RE: Change Order #5  
Tree and Fence Removal at NBHS & BCHS

## Change Order

# Change Order Request 6 - PCO #17 - RFP 02 - Remove tree/fence lines at NB, BC

# REQUEST FOR PROPOSAL

**Item 1:** REFERENCE DRAWING MARK-UPS on C4.0 for BC and NB:

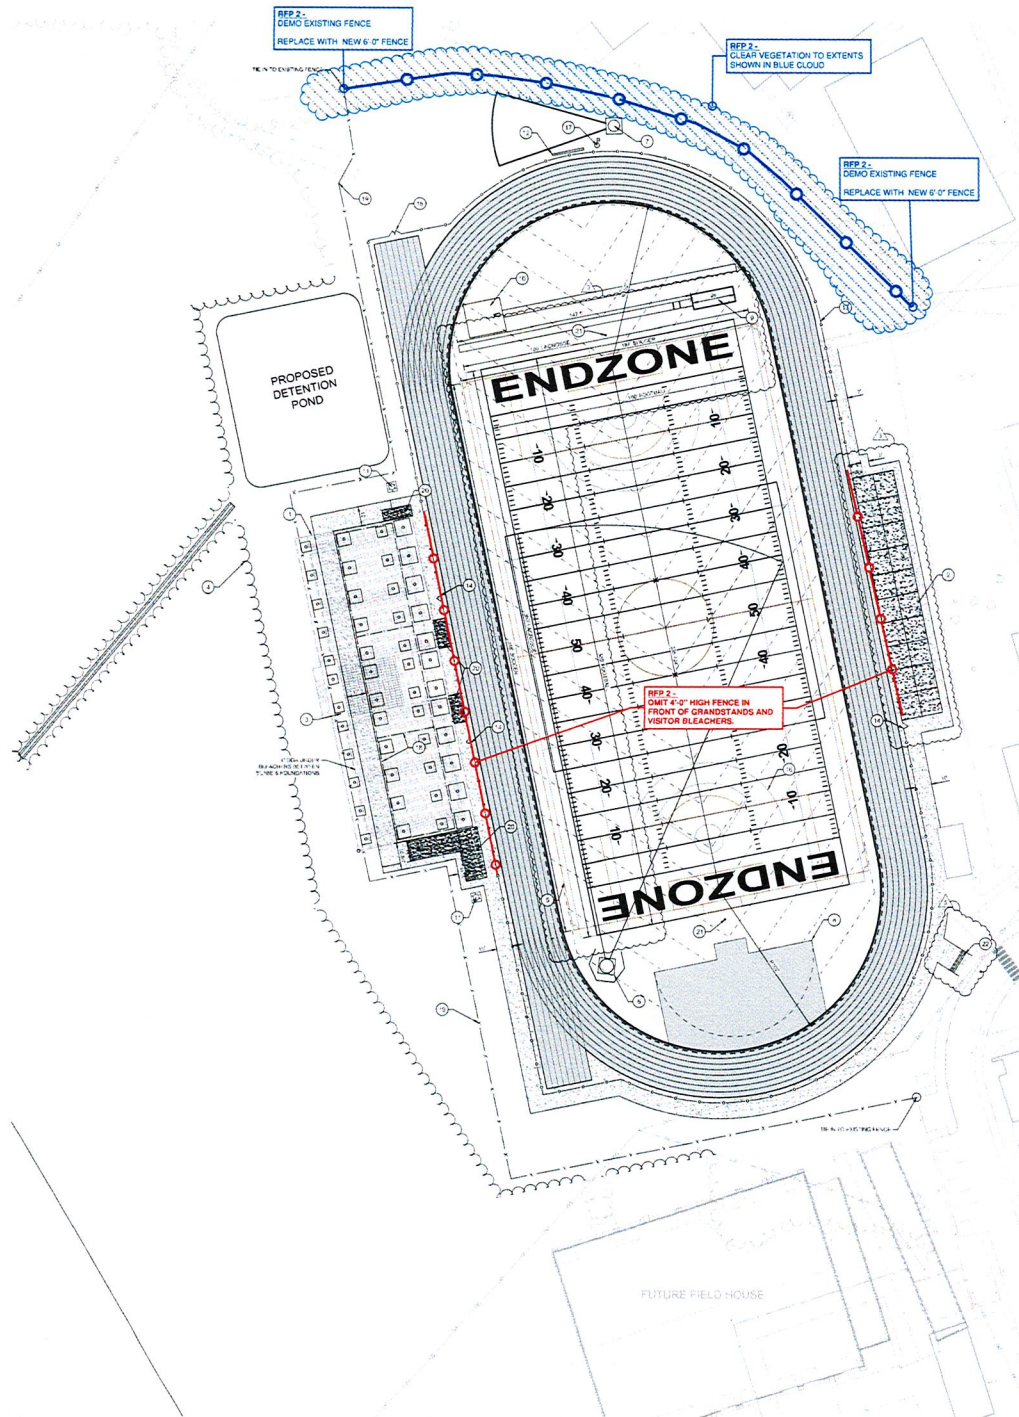
- OMIT 4'-0" High Fence at Bleachers/Grandstands. (Red Mark-Up)
- PROVIDE Site Clearing at South Endzone of NB and North Endzone of BC. (Blue Mark-Up)
- PROVIDE 6'-0" High Fence at Endzones as documented with mark-ups. (Blue Mark-Up)
